ADDENDUM NO. 2

Corporate FBO Terminal Building and Parking Lot Rehabilitation

Passero Associates Project No. 20202946.010A

ADDENDUM NO. 2
Corporate FBO Terminal Building and Parking Lot Rehabilitation
Macon-Bibb County at Middle Georgia Regional Airport
Thursday, December 5, 2024

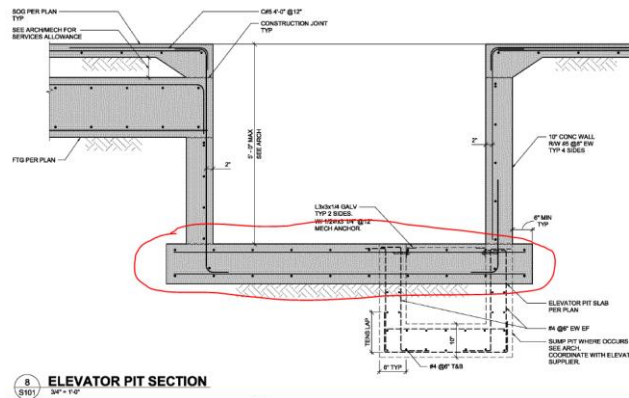
Q3: Please confirm If the header curbs below is what is intent to price and not curb and gutters (not curb and gutters details on the drawings).

A3: Correct. Price header curbs. Curb and gutters do not need to be priced out.
